Service Bulletin 513

Issue 1 - July 2014

Subject: Camshaft Chain Chest Sound Suppression Bolt				
Bulletin Number	Models Affected	VIN Range		Markets Affected
513	Daytona 675 ABS	From To	See Appendix A	All
	Daytona 675 R ABS	From To	See Appendix A	All
	Rocket III Roadster ABS	From To	See Appendix A	All
	Sprint GT ABS	From To	See Appendix A	All
	Speed Triple ABS	From To	See Appendix A	All
	Speed Triple R ABS	From To	See Appendix A	All
	Tiger Sport ABS	From To	See Appendix A	All

Daytona 675 ABS, Daytona 675 R ABS

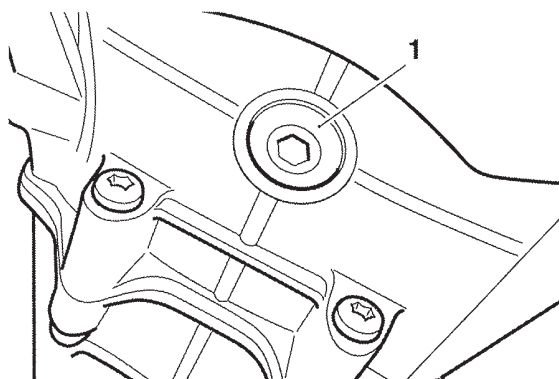
1. Remove the seat as described in the service manual.
2. Disconnect the battery, negative (black) lead first.
3. Remove the right hand fairing as described in the service manual.
4. Check and if necessary tighten the camshaft chain chest sound suppression bolt to **12 Nm**.

1. Radiator upper mounting bolts

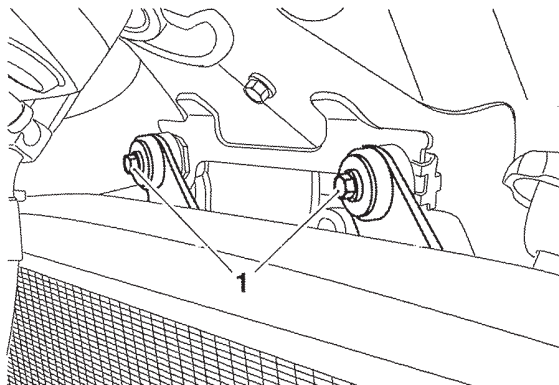
3. Remove the radiator covers, as described in the service manual.
4. Remove the radiator front grille, as described in the service manual.
5. Release the radiator upper mounting bolts.

1. Camshaft chain chest sound suppression bolt

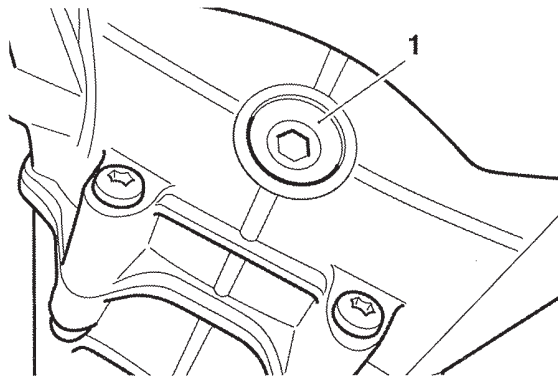
8. Ease the radiator towards the right hand side of the motorcycle to dislodge it from its lower mounting stud.
9. Check and if necessary tighten the camshaft chain chest sound suppression bolt to **12 Nm**.

- 1. Camshaft chain chest sound suppression bolt**
5. Refit the right hand fairing as described in the service manual.
6. Reconnect the battery, positive (red) lead first and tighten the battery terminals to **4.5 Nm**.
7. Refit the seat, as described in the service manual.

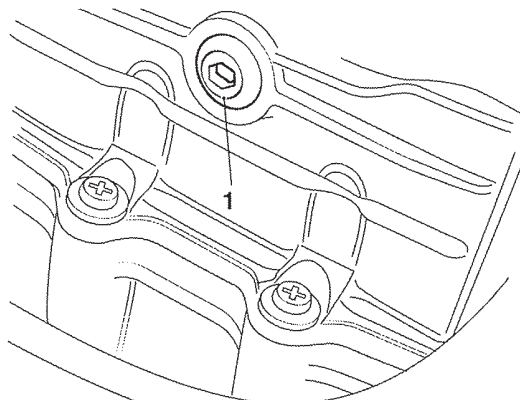
4. Check and if necessary tighten the camshaft chain chest sound suppression bolt to **10 Nm**.

- 1. Camshaft chain chest sound suppression bolt**

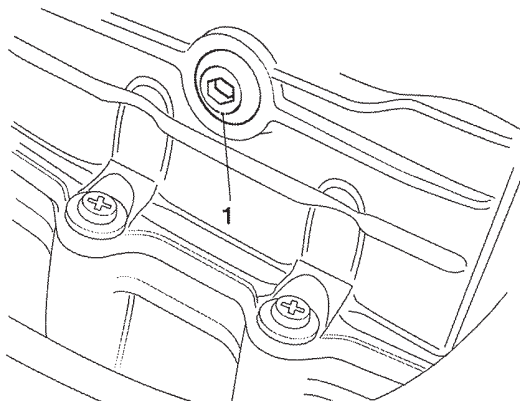
1. Check and if necessary tighten the camshaft chain chest sound suppression bolt to **10 Nm**.
